Upgrades to John Palmer Public School (SSD-23330227): Amended Plans in accordance with Condition B1

I refer to SSD Application SSD-23330227, upgrades to John Palmer Public School, approved on the 20 May 2022.

LANDSCAPE PLAN

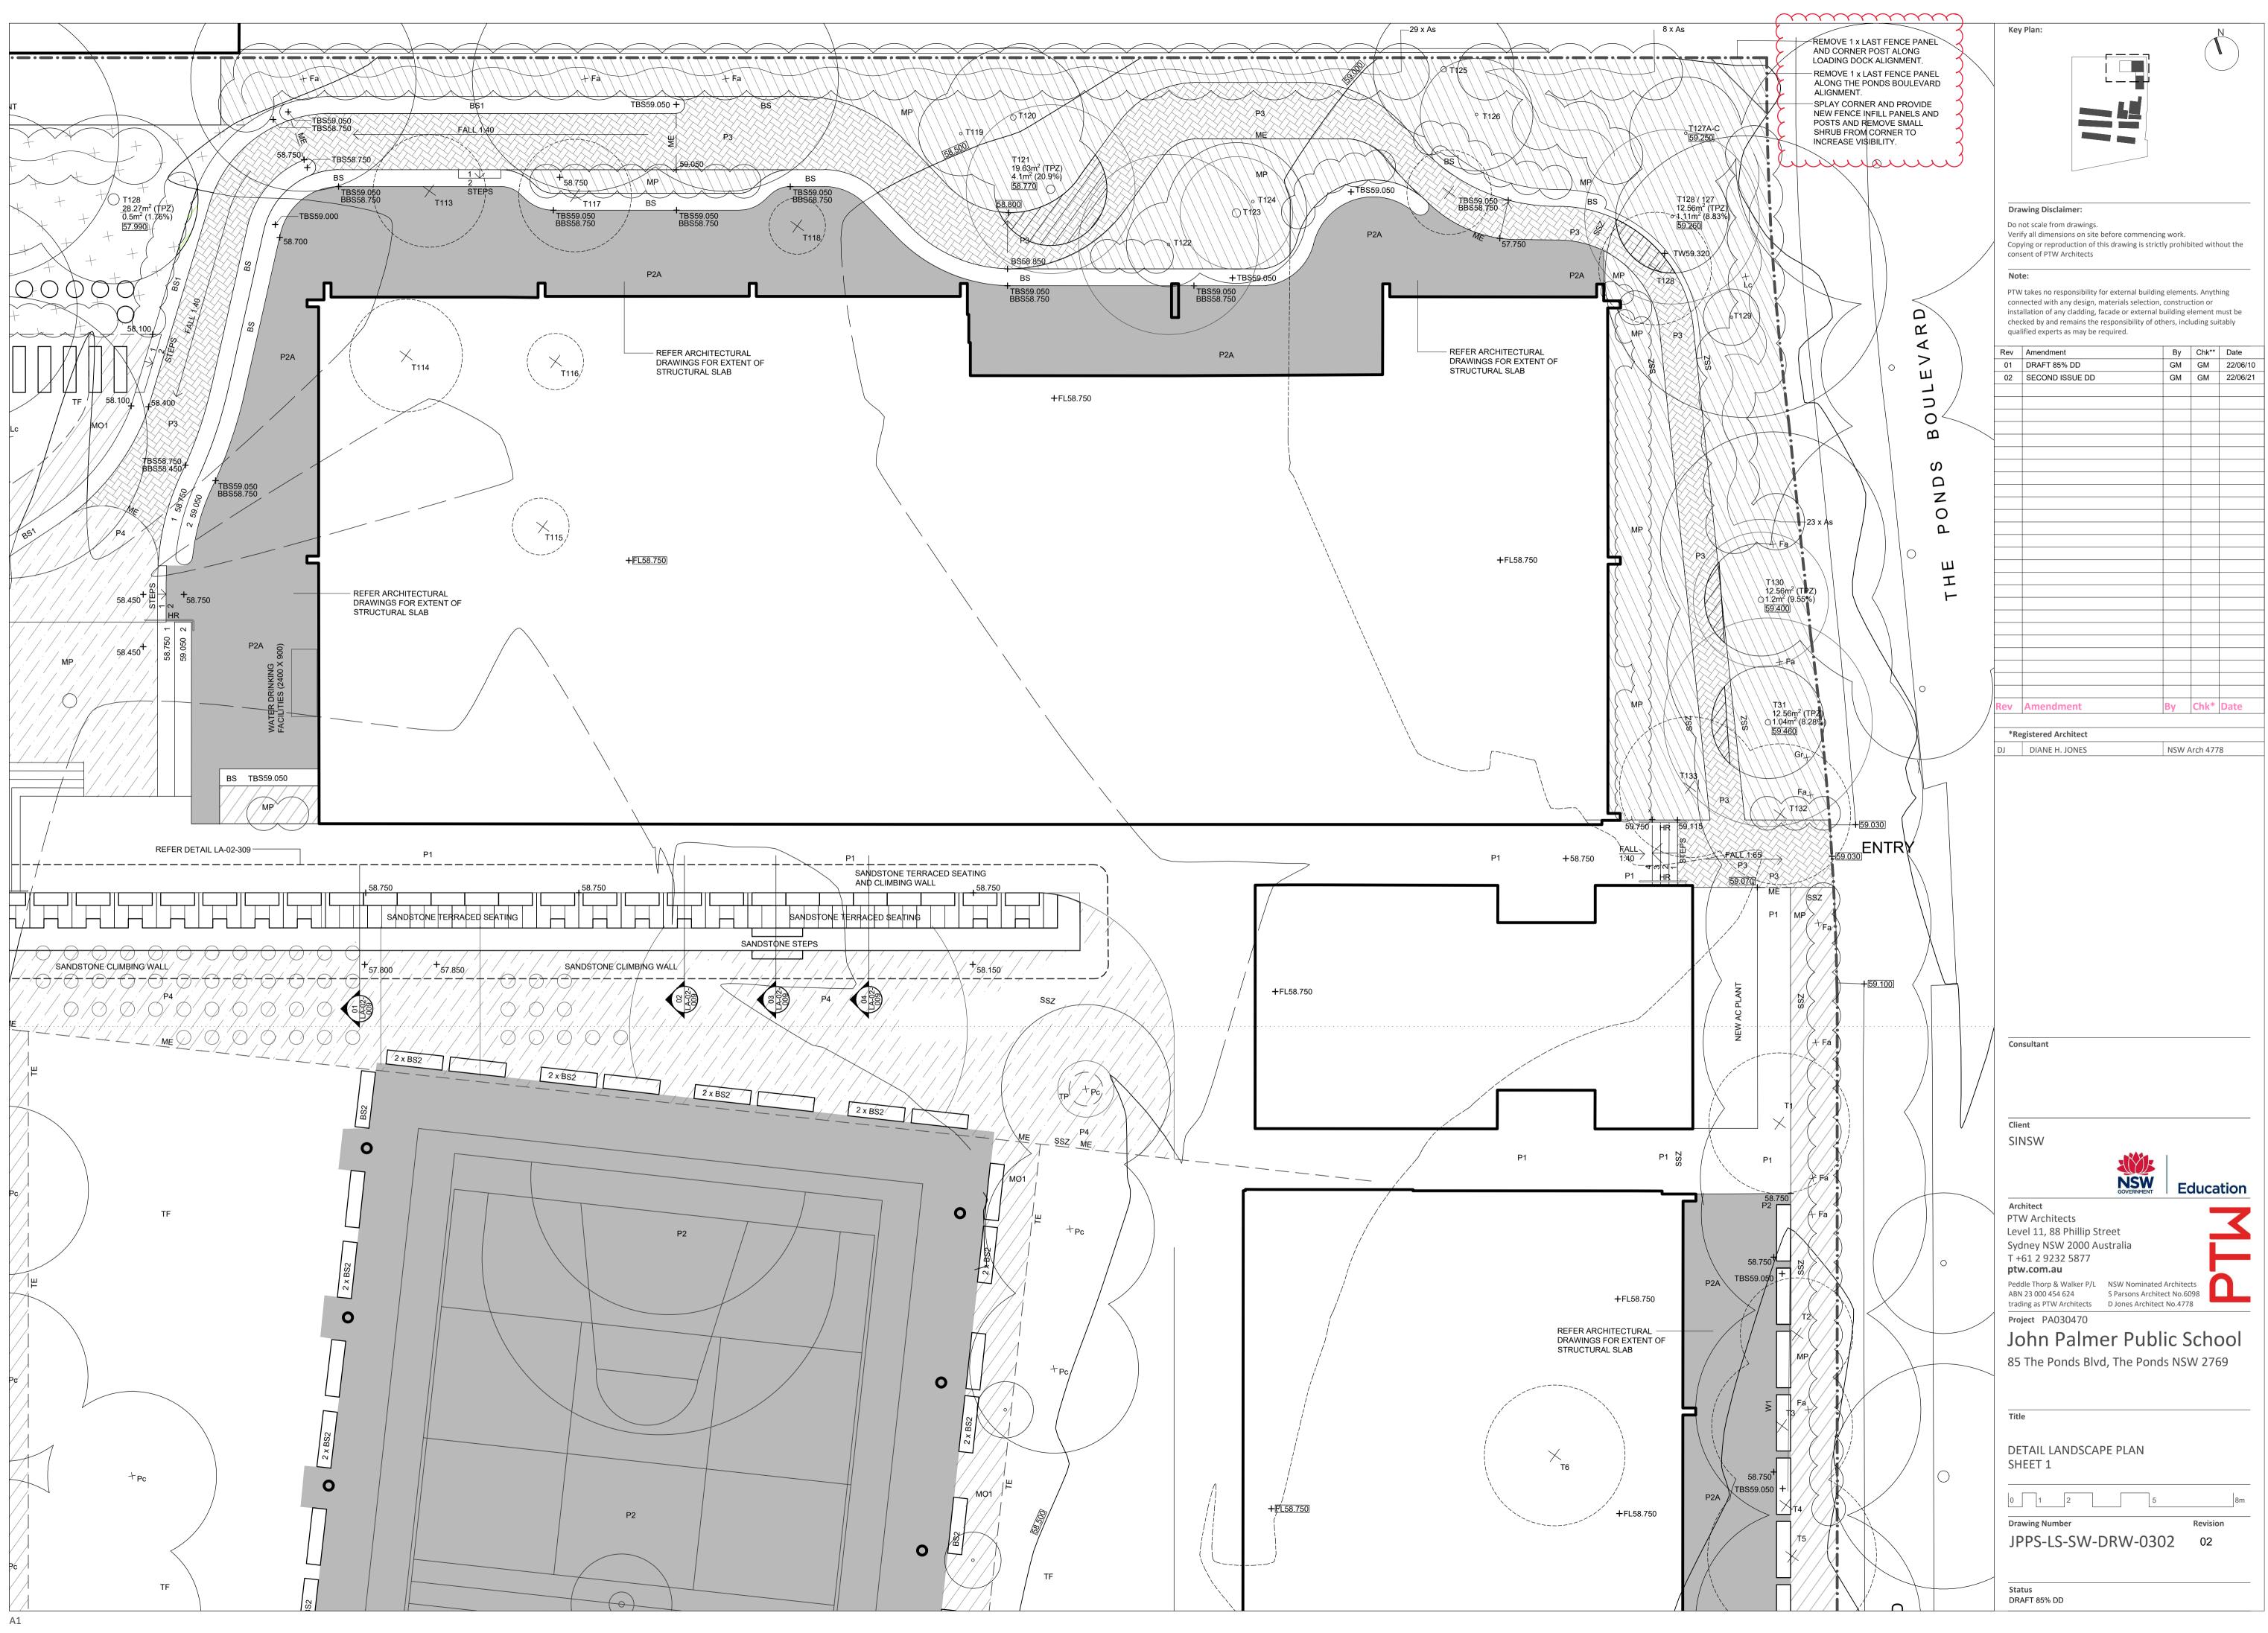
Demonstration of Compliance	Drawing(s) Reference
Number		
B1 (a)	Drawing annotation added to remove	JPPS-LS-SW-DRW-0301_02
	last fence panels, post and small	JPPS-LS-SW-DRW-0302_02
	shrub to splay boundary fence.

B1 (b)	Refer to Landscape Plan Note 3 mandating condition B1(b). Typical details for topsoil, turf and vegetation included in landscape drawings.	JPPS-LS-SW-DRW-0301_02 JPPS-LS-SW-DRW-0307_02 JPPS-LS-SW-DRW-0310_02
B1 (c)	Refer to Landscape Plan Note 4 mandating condition B1(c).	JPPS-LS-SW-DRW-0301_02
B1 (d)	Refer to JPPS SSD-2333027 – Condition BO2 Notification for evidence demonstrating that additional on-site staff car parking is not feasible.	DOC22/550949

3. BATTERS MUST NOT
E 1, CONCRETE	AND MUST BE STABILISED WITH TOPSOIL, TURF AND VEGETATION
	4. FINISHED LEVELS OF ALL INTERNAL WORKS AT THE

ROAD BOUNDARY OF THE PROPERTY MUST BE 4% ABOVE THE TOP OF THE ADJACENT KERB
